Planning & Zoning Board

Thursday, February 8, 2024

RE: Heart Food Pantry; 6541 E. Main Street: Major Site Plan and Variance Request

On behalf of the City of Reynoldsburg, EMH&T conducted a preliminary engineering review of the Major Site plan for the Heart Food Pantry and Market project located at 6541-6543 East Main Street. Previous reviews of the plan and traffic study were conducted in October and December of 2023. The following summarizes our findings and recommendations with respect to this development.

SITE PLAN
FOR
HEART DEVELOPERS LLC
EXISTING CONDITIONS

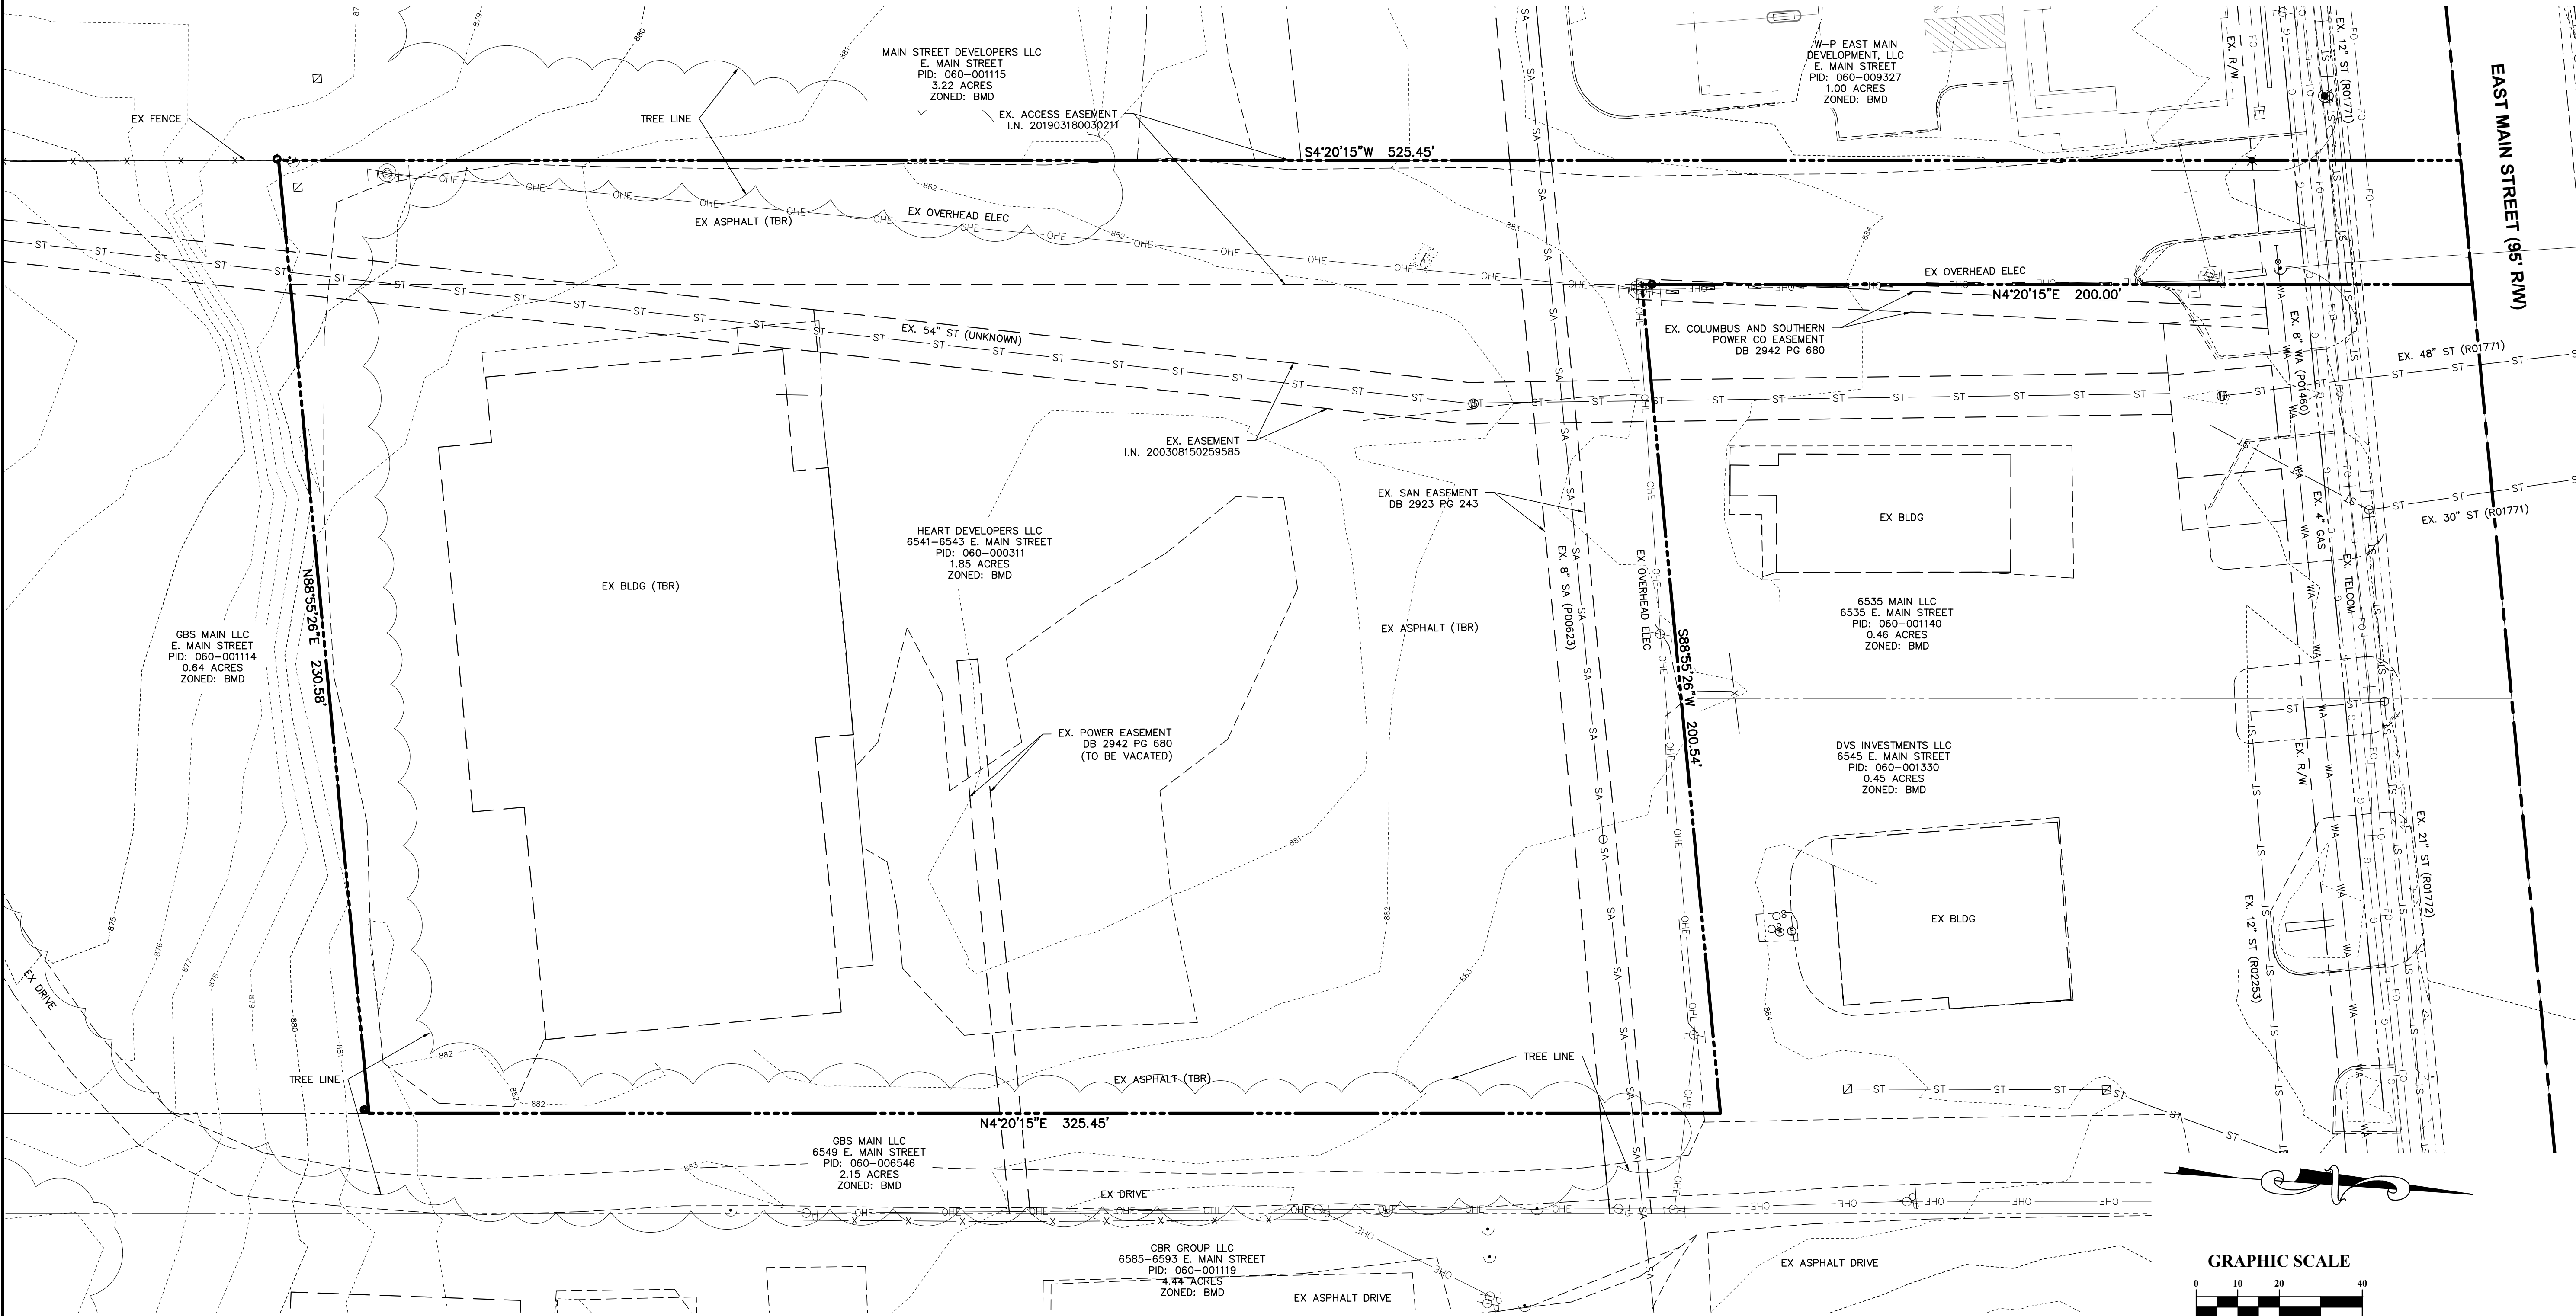
14. The site plan shows an easement running north to south containing a 54-inch storm sewer which conveys stormwater from East Main Street and outlets to an existing stream to the south of the proposed site. Please show all pertinent details of the storm sewer on future submissions. The City assumes this storm sewer was field verified and that it will continue to be maintained through the site, please confirm.
15. The underground detention system location is noted. Please provide a stormwater management report meeting the requirements of the City's current Stormwater Design Manual with supporting calculations and plan details with the PGU.
16. Verify that no FEMA mapped floodplain is present on the site. If present, please show on the plan.

1 ARCHITECTURAL SITE PLAN
Scale: 1" = 20'

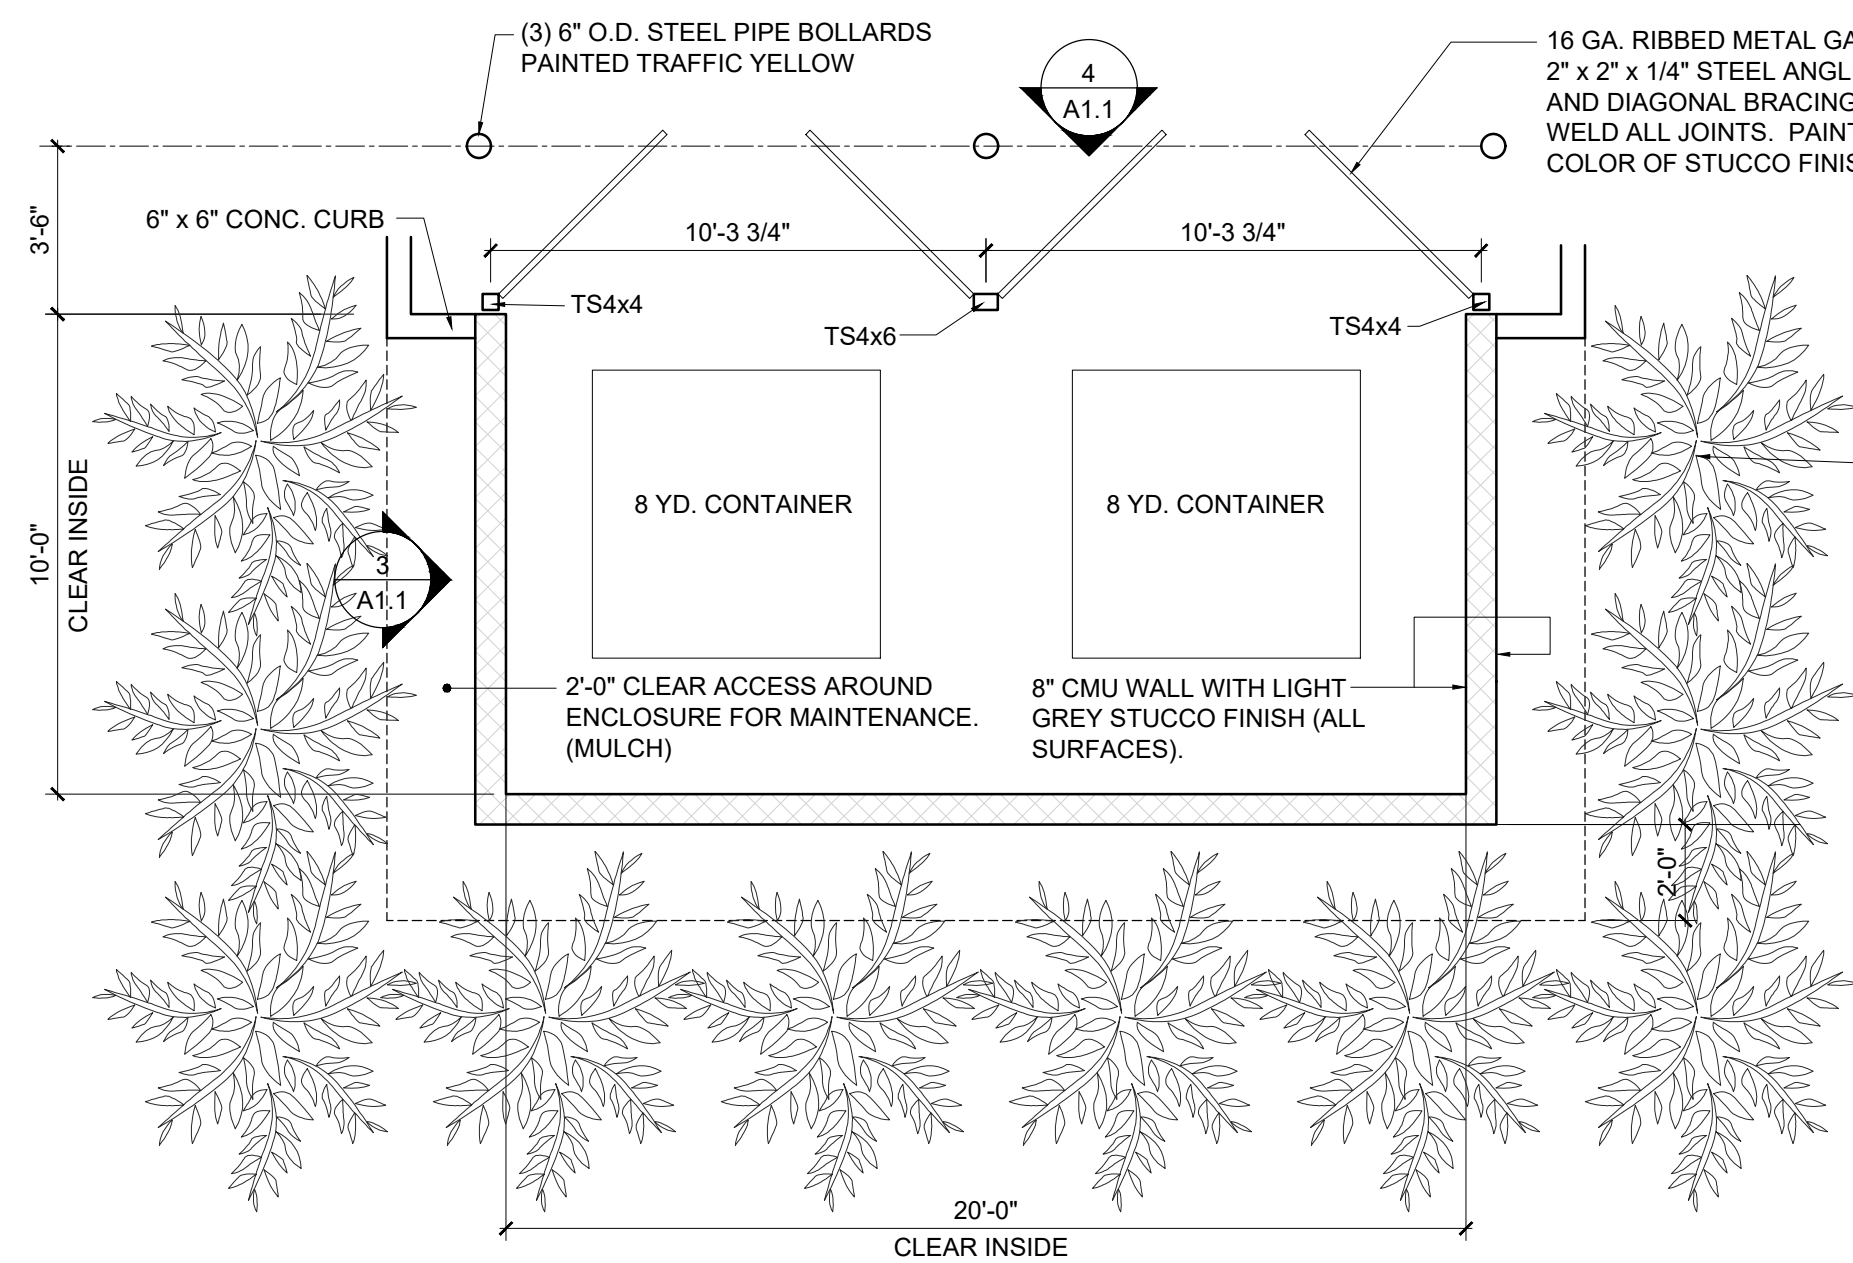
- c. **Lot Coverage (Max.):** Maximum permitted impervious coverage is 80%. The plan indicates 76.9% impervious coverage.
- d. **Open Space (min.):** Minimum required open space is 30%. The site is 1.85 acres or 80,685 sq.ft. and 30% is equal to 24,205.5 sq.ft. The plan indicates 14.8% or 11,957 sq.ft. is provided, requiring an additional 12,248.5 sq.ft. Open space shall not include area for required minimum yards.

The applicant is requesting a variance to permit a reduction of required minimum open space from 30% to 14.8% as planned.

- e. **Parking:** Parking is permitted to the interior of the development or within a parking structure. The plan illustrates the parking encompassing the building. However, the buildable area of the parcel does not have road frontage and is buffered with other development. The code requires one parking space for each 300 sq.ft. of building, requiring 40 spaces, including 2 accessible spaces. The plan proposes 108 parking spaces, including 6 accessible spaces, which is a ratio of 1 space per 109 sq.ft.. The parking will be screened from adjacent properties with an evergreen hedge.

- f. **Loading Spaces:** 1 loading space is required per 10,000 sq.ft of building area, and for each additional 10,000 sq.ft. or major fraction thereof. The proposed use is required to have 2 loading spaces. The plan indicates 2 loading spaces.

- m. **Buffer Requirements:** No buffering conditions apply to the site and uses.
- n. **Parking area landscaping:** For every ten (10) parking spaces or fraction thereof, the applicant shall provide not less than two hundred (200) square feet of interior landscaped parking lot areas containing at least one (1) tree with a minimum diameter of two inches (2") and four (4) shrubs. The plan proposed 108 parking spaces, requiring 11 trees, 44 shrubs, and 2,160 sq.ft. of landscape area. Interior landscape tree requirements may be applied to this requirements, provided the trunk diameter is 2" min. The plan provides 3,165 sq.ft. of parking island landscape area, 13 trees specified as 2" caliper, and 46 shrubs.

- i. Ornamental trees are being provided in the parking islands where there appear to be conflicts with overhead utility lines. Note above comment regarding substitution of the specified Crape Myrtle trees.

- o. **Parking perimeter landscaping:** All parking lots shall provide perimeter landscaping. Parking lots shall have perimeter landscaping of a minimum width of ten feet (10') exclusive of vehicle overhang. The perimeter landscaping shall consist of a continuous evergreen hedge, evergreen trees, earthen mound or a combination thereof as required to provide a continuous opaque screen, a minimum of thirty-six inches (36") in height, within one (1) year of installation. The perimeter landscape shall also contain a minimum of one (1) deciduous tree per fifty (50) linear feet of parking perimeter. The plan provides the required evergreen screen hedge and 1 deciduous tree per 50 feet.

- a. Approval is recommended for Heart Food Pantry; 6541 E. Main Street: Major Site Plan with the following conditions:
 - i. That the layout is revised to provide the permitted minimum 30% open space, or a variance is granted to allow a reduction to 14.8%, a difference of 12,248.5 sq.ft.
 - ii. That final detailed signage designs are submitted for approval prior to installation.
 - iii. That the specified Crape Myrtle plants be substituted with a locally appropriate ornamental tree.
 - iv. That the plan is modified per the engineering recommendations for the access drive to be 20 feet and its adjacent sidewalk to be 5 feet wide.

2 PLAN at DUMPSTER ENCLOSURE
Scale: 1/4" = 1'-0"

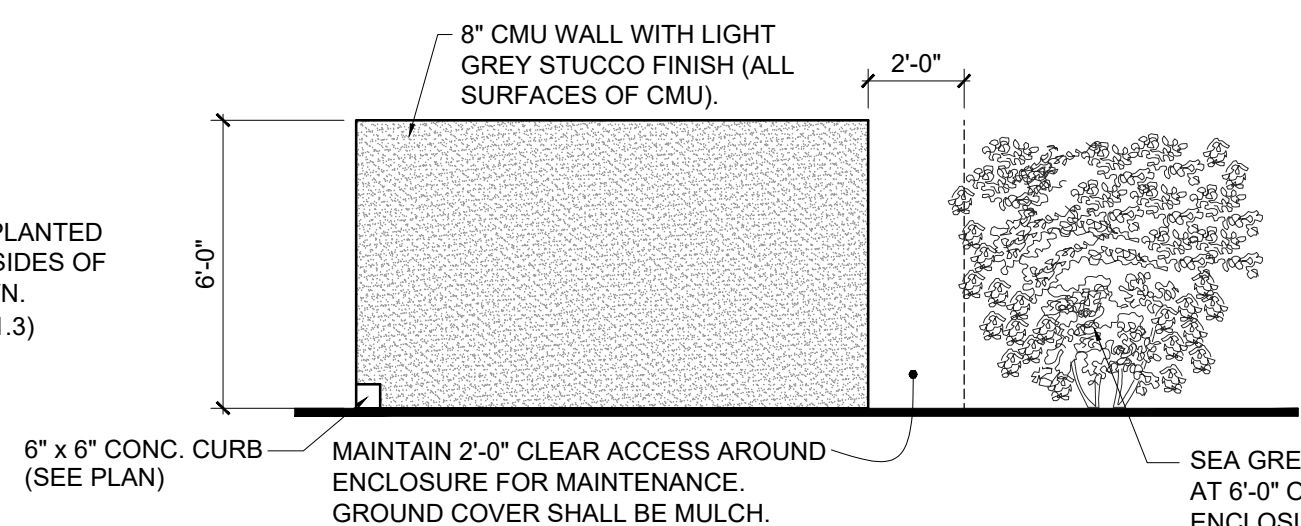
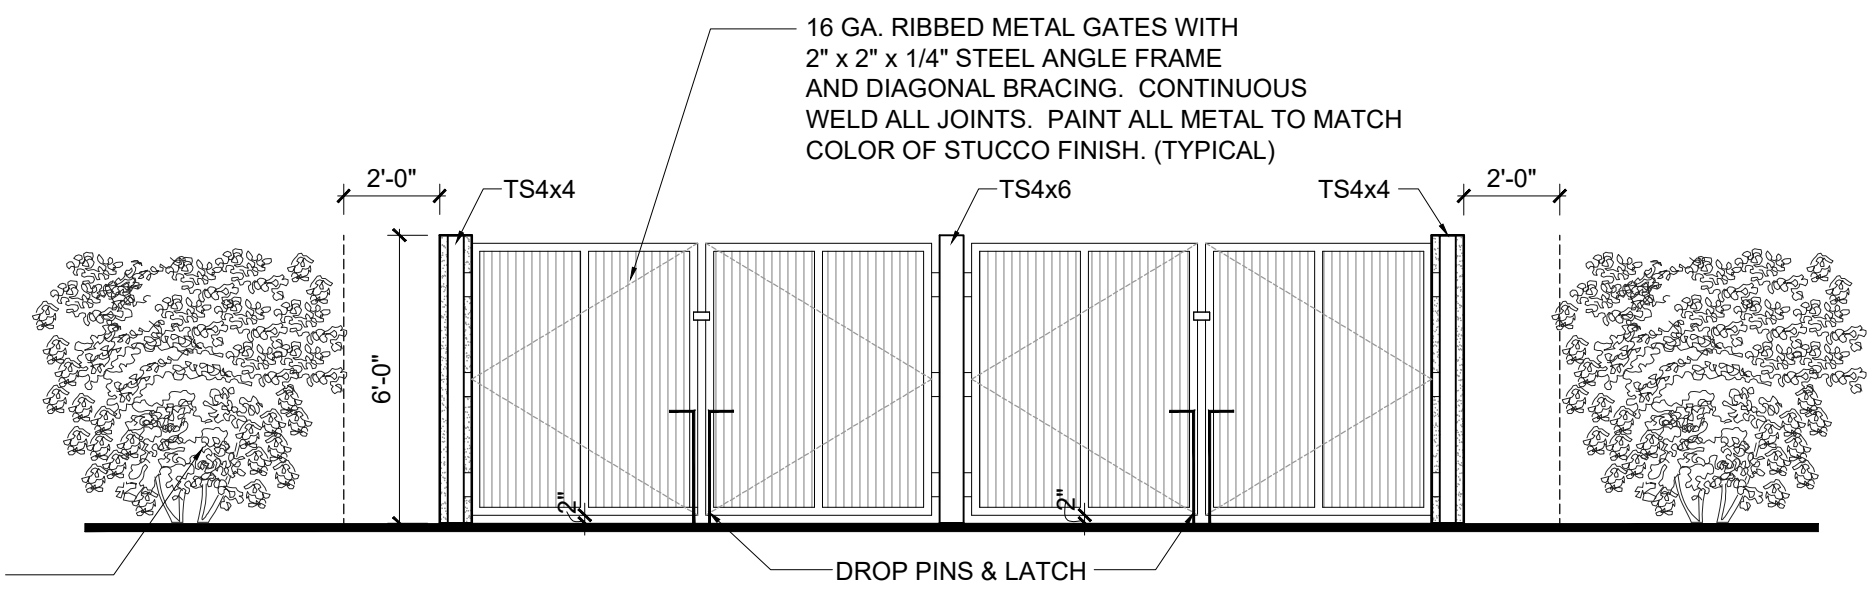
- p. **Screening and Landscaping for service structures:** The dumpster must be screened with a continuous solid opaque fence, wall, or mound, and have a continuous planting of evergreen plant material on all sides except for the gated access. The average height of the screen shall be 1' taller than the equipment being screened. The plans indicate a 6' tall dumpster enclosure, finished in grey stucco with a matching-color painted metal gate and evergreen screen shrubs.
